TECHNICAL SERVICE BULLETIN

Vehicles Equipped With A 2.0L (Panther) Engine – Rattle Type Noise From The Transmission Area At Light Accelerator Input

23-2263

This bulletin supersedes 23-2211. Reason for update: Incorrect Procedure

Figure 1

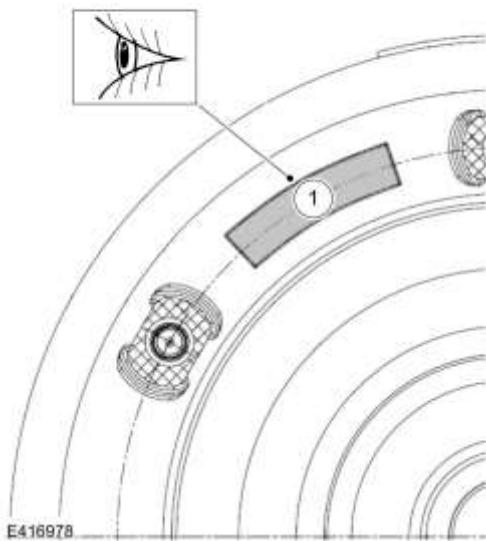
7. Remove the transmission and verify the torque converter part number Prefix and Suffix. Ensure the torque converter part number is JB3P-(7902)-JD or later. If the part number is JB3P-(7902)-JC or earlier, then replace the part with a new torque converter (JD or later). (Figure 1)

Callout 1: Ford Part Number Prefix and Suffix 3mm Max High Here
